# FINAL MISSION BAY SUBSEQUENT ENVIRONMENTAL IMPACT REPORT

PLANNING DEPARTMENT FILE NO. 96.771E

## VOLUME III: SUMMARY OF COMMENTS AND RESPONSES

FIGURE V.B.1 (REVISED) ASSESSOR'S BLOCKS AND LOTS COMPRISING THE PROJECT AREA

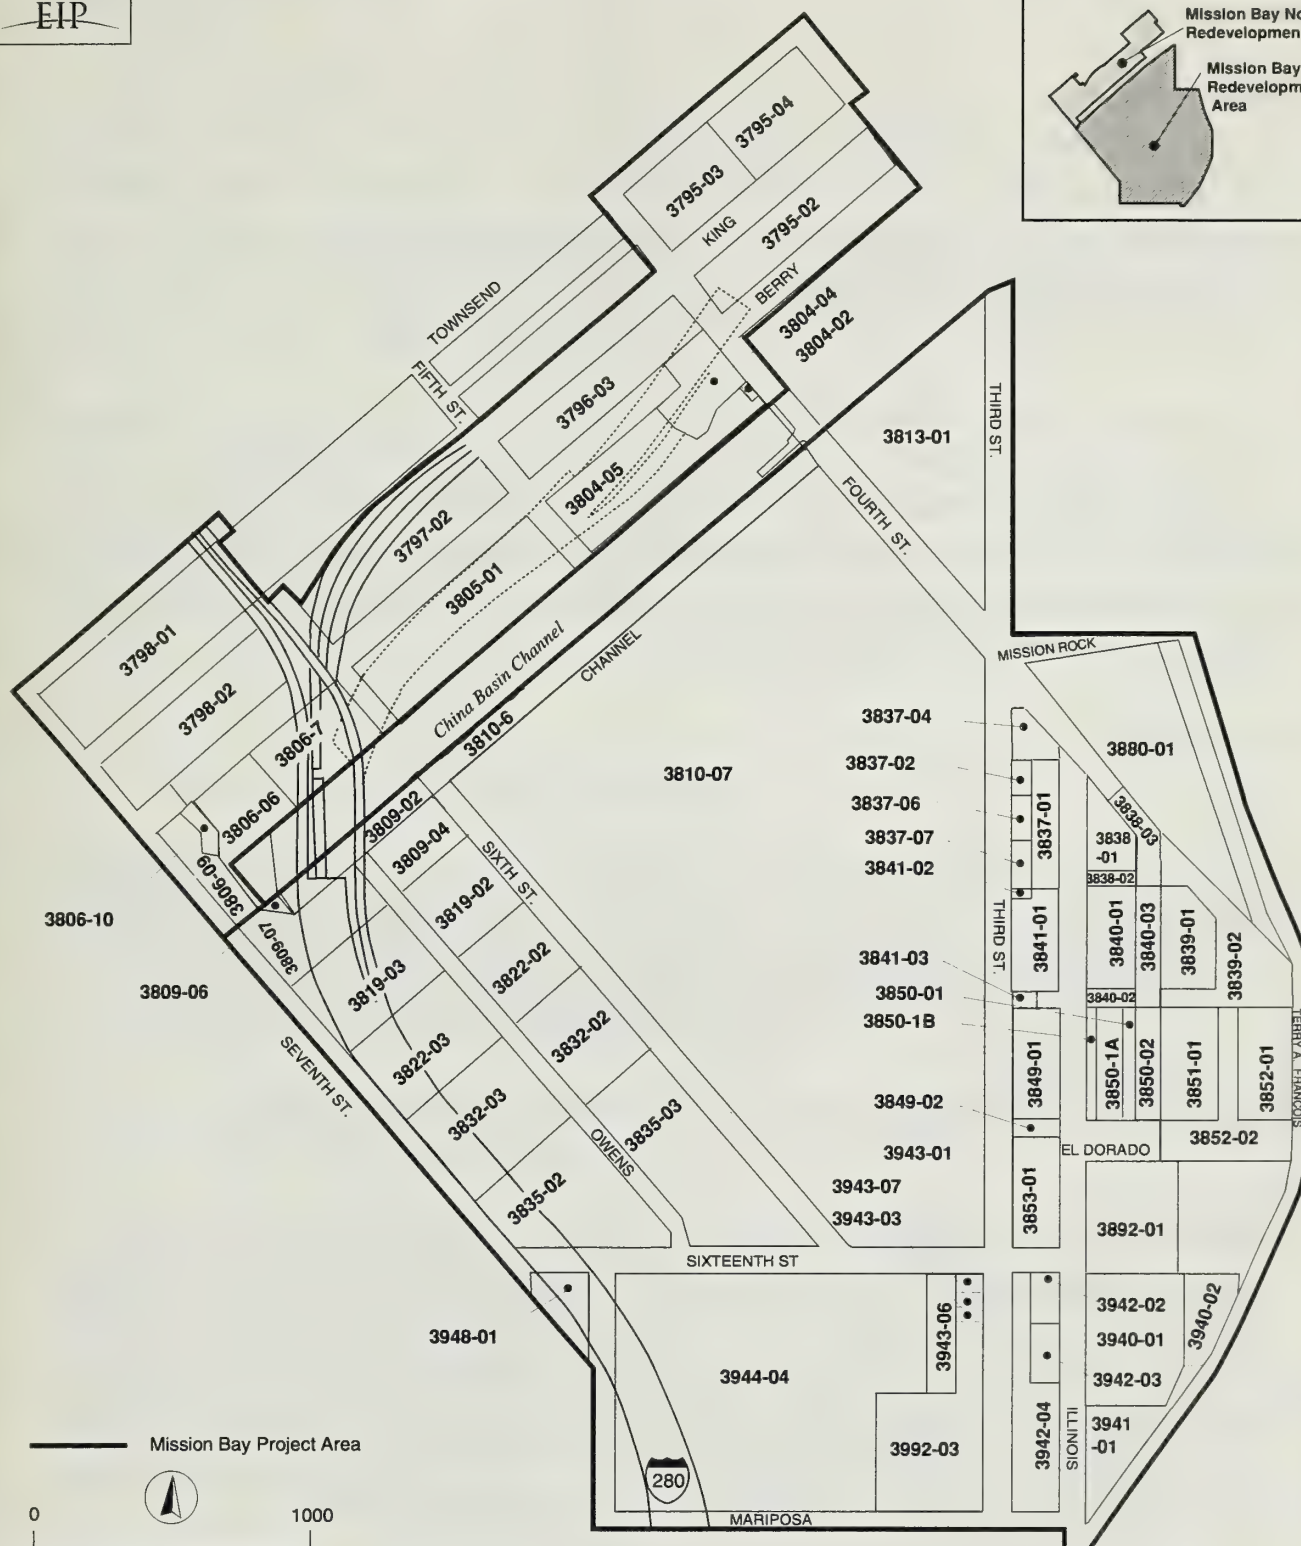
First thing I noticed is that the project boundaries include a lot of Cal-Train property and right-of-way, and so forth. That's really not the correct thing to do. The project boundary should be revised and exclude all Cal-Train properties, easements and rights-of-way, including the one on Seventh Street and any environmental impacts should be corrected on the report. (*Norman Rolfe, San Francisco Tomorrow*)

The project boundaries as given in subject report include land under control of Caltrain, i.e. - the Peninsula Corridor Joint Powers Board (JPB). Since this land probably will not be available for this project, the project boundaries should be revised to eliminate all land under control of the JPB, including Caltrain right-of-way along Seventh Street. (*Jennifer Clary, Mary Anne Miller, Norm Rolfe, San Francisco Tomorrow Mission Bay Committee*)

Many of the figures in the DEIR show the existing Caltrain right-of-way as some use other than railroad. No portion of the Caltrain right-of-way has been vacated or abandoned (Figure V.B.2). The figures should be clarified to show that Caltrain intends to continue occupying all of the property for the purpose of operating train service indefinitely. Caltrain is now in the process of developing plans to reconfigure and improve its track, signals, buildings and other facilities at its 4th and Townsend Street terminal. (*Darrell J. Maxey, P.E., Chief Engineer, Caltrain*)

p. III.4 that refers to Figure III.B.2. Figure V.B.1 shows the Assessor's Block and Lot numbers within the Project Area. Figure V.B.1, p. V.B.2, and Figure I.1, p. I.45, have been amended to correct Assessor's Block and Lot numbers: 1900 Third Street from 3922-03 to 3992-03; 3848-01 to 3948-01 at Pennsylvania and 16th Streets; and to add AB 3837-01 to the site behind the Third Street Properties. (Revised Figure V.B.1 is shown on the following page.) As with the Catellus-owned sites, development on other private properties would be subject to the Redevelopment Plans and Design for Development documents, if adopted, the conditions of approval of the project including relevant mitigation measures, as adopted, and any other agreements, including Owner Participation Agreements, that individual property owners may enter into with the Redevelopment Agency or the City.

As the comments suggest, Caltrain controls the right-of-way along Seventh Street; however, the underlying title is held by Catellus, as shown in Figure III.B.2. The Caltrain right-of-way is appropriately designated public facilities in Figure III.B.3, which shows the Land Use program. Figure V.B.2 shows parking and open land area over the active tracks since they are in use during the day. As noted in the response in Land Use, "Active Freight Rail Lines" on p. XII.51, Figure V.B.2 is amended to designate the active rail freight lines.

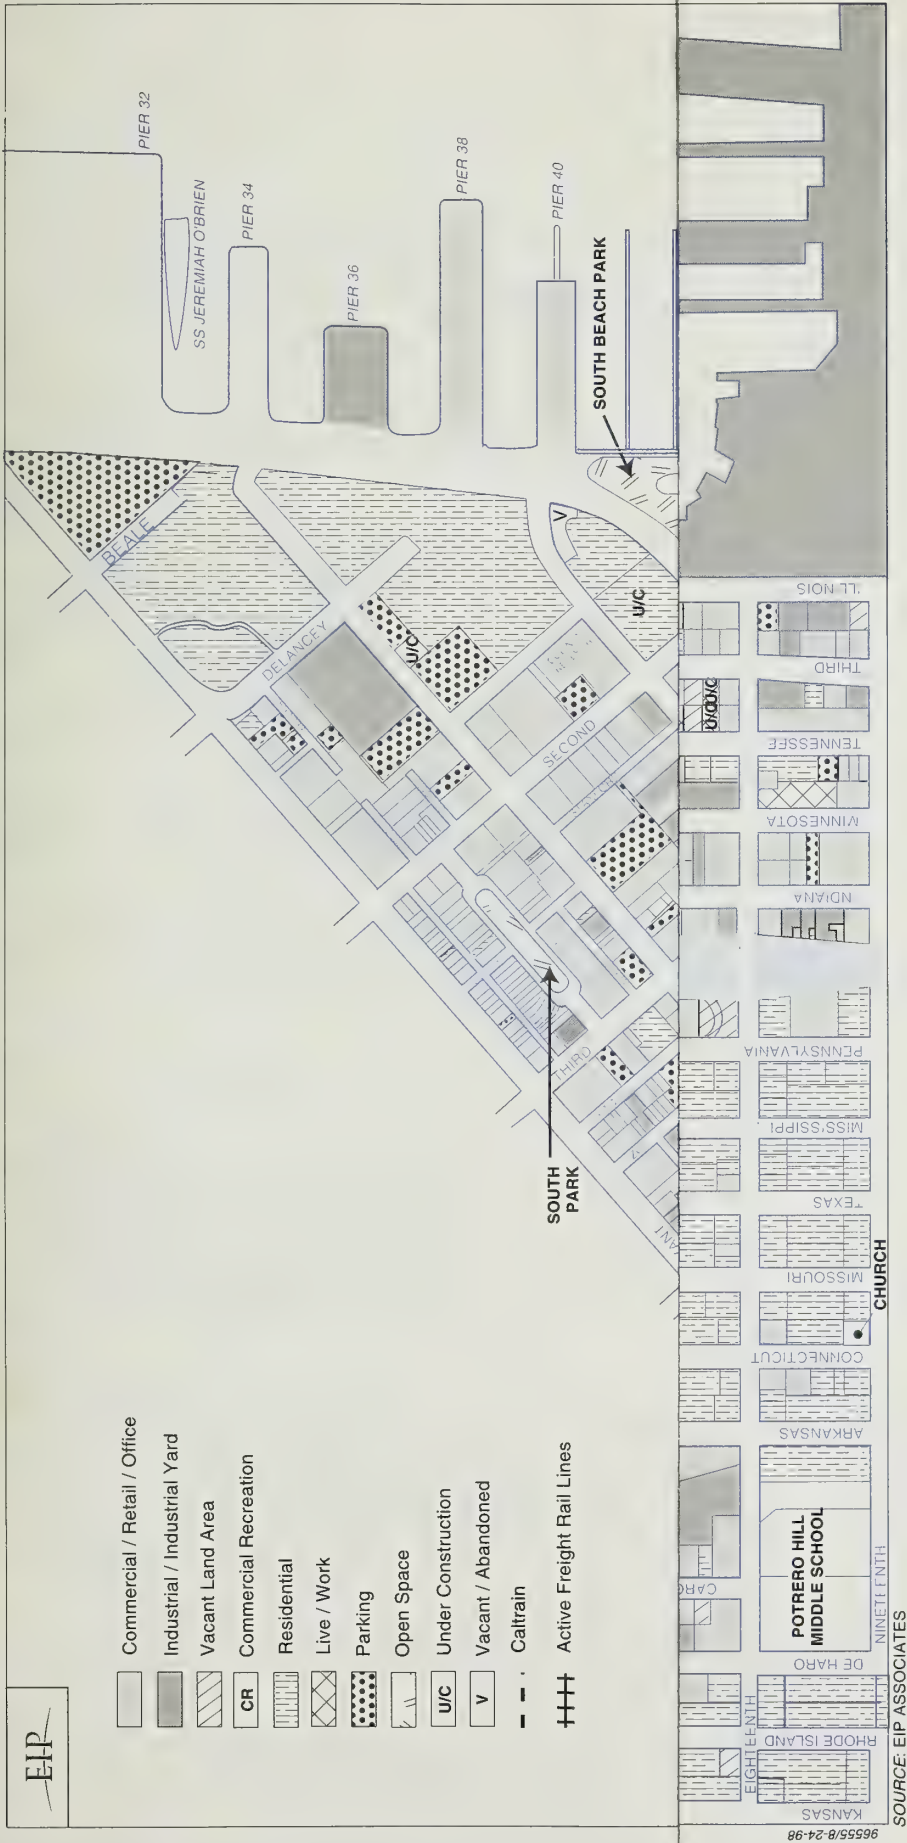
Figure V.B.2: Active railroad right-of-way (the “wye” junction from the Caltrain tracks between Sixteen and Mariposa Streets leading to Illinois Street) is incorrectly marked as having an existing land use of “Parking” or “Vacant.” (*Richard Mlynarik*)

Figure V.B.2, Land Use in the Project Area and Vicinity, does not indicate the “y” junction from Seventh Street to Illinois Street (which is correctly indicated on Figure V.E.7). The legend of Figure V.B.2 is amended to include “Active Freight Rail Lines.” The active freight rail lines replace open land area and parking uses extending northeast from I-280 at 17th Street, across 16th Street, through the northwest corner of Third Street and 16th Street, across Third Street, into the Illinois right-of-way north to Mission Rock Street.

**FIGURE VI.1 (REVISED) WEEKDAY P.M. PEAK HOUR LEVELS OF SERVICE:  
EXISTING WITH PROJECT, MITIGATED**

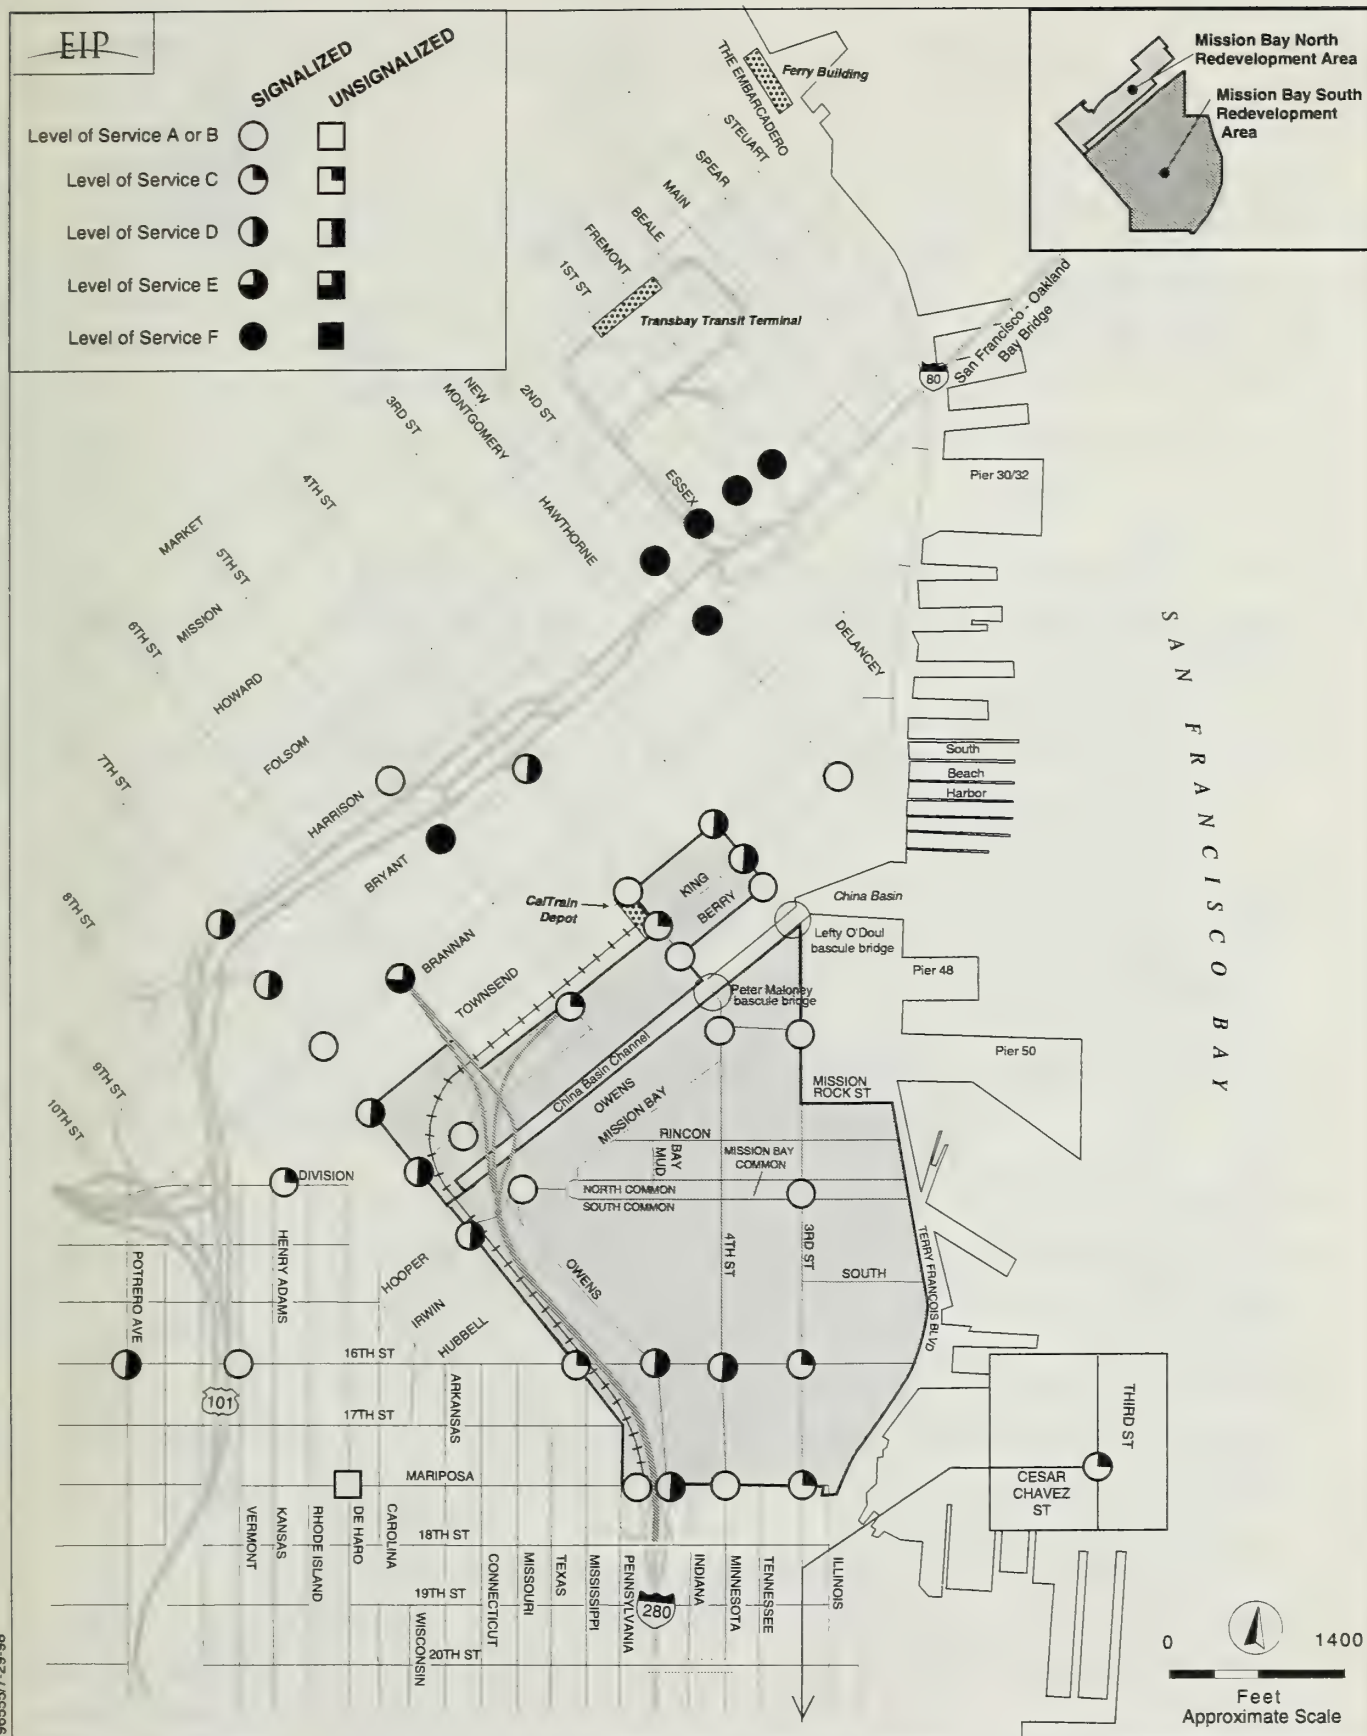
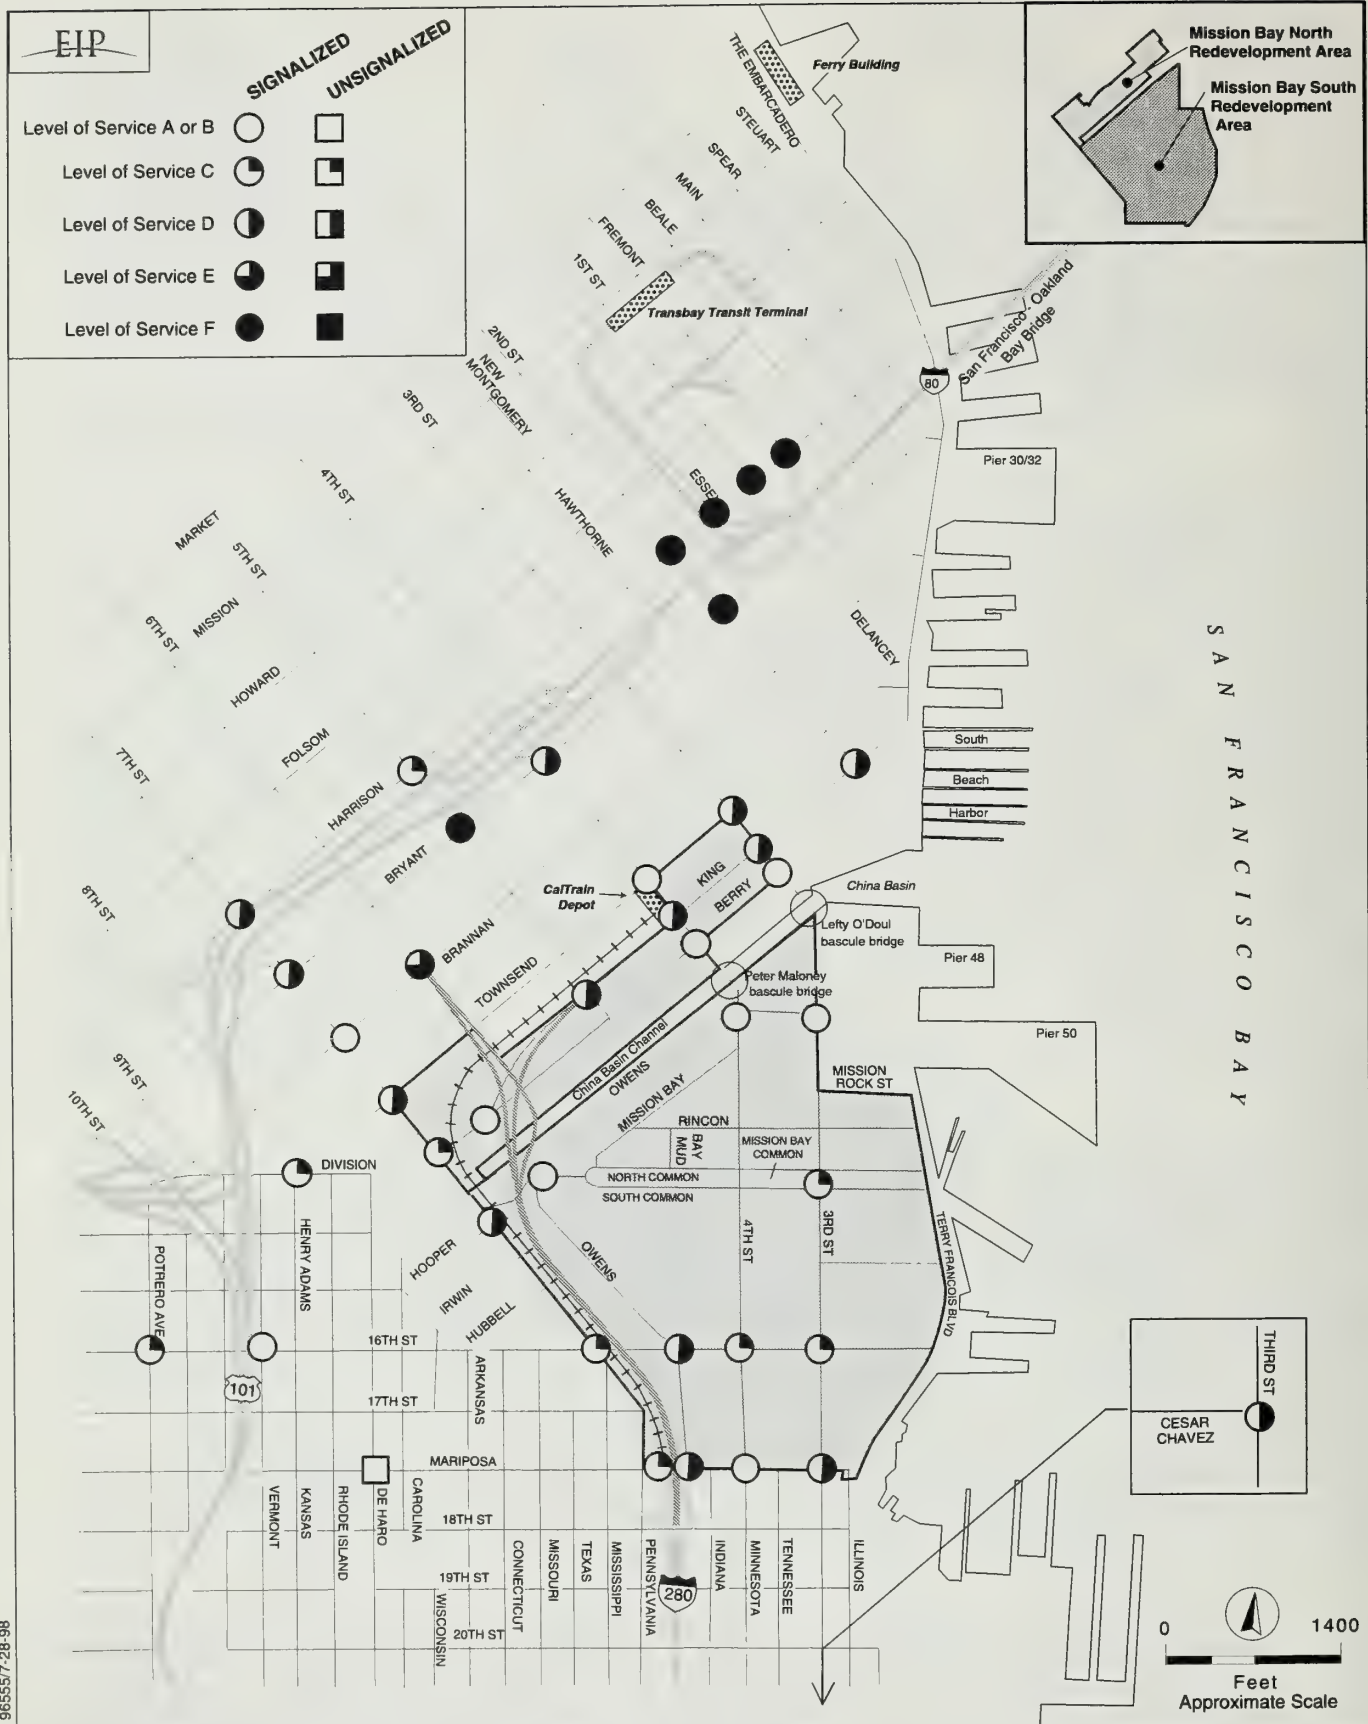
Figure VI.2: LOS indications for the Fourth/King and Fourth/Brannan intersections are not shown (but are present in the corresponding Figure VI.1). Also, figure VI.2 (project cumulative) shows the King/Berry intersection at LOS "C" when it was already at level "D" in Figure VI.1 (existing plus project). This cannot be correct. (*Richard Mlynarik*)

A level of service (LOS) for the intersection of Fourth and Brannan Streets was shown in error on Figure VI.1. This intersection is not a study intersection, and the figure has been corrected to eliminate the LOS marker for this intersection. The LOS marker for the intersection of Fourth and King Streets was inadvertently not shown on Figure VI.2. The intersection of Fourth and King Streets is expected to operate at LOS D under cumulative mitigated conditions. Figure VI.2 has been corrected to indicate this. Both corrected figures are shown on pp. XII.169 and XII.170.

The level of service for the intersection of King and Berry Streets is shown as operating at LOS B under both Existing With Project Mitigated conditions and Year 2015 Cumulative Mitigated conditions. The comment is most likely referring to the intersection of Berry and Seventh Streets, that is shown to operate at LOS D under Existing With Project Mitigated conditions, and to operate as LOS C under Year 2015 cumulative mitigated conditions. These LOS calculations are correct. Under the Existing-With-Project conditions, the intersection would operate at LOS D, and therefore would not require a mitigation measure. However, after adding cumulative traffic growth to the intersection, the operation of the intersection would degrade to LOS F (see p. V.E.69), therefore requiring mitigation. The application of the mitigation measure described in Table VI.5 on p. VI.22 would improve the operation of the intersection to LOS C; therefore, Figure VI.2 is correct in showing the Berry and Seventh Streets intersection at LOS C.
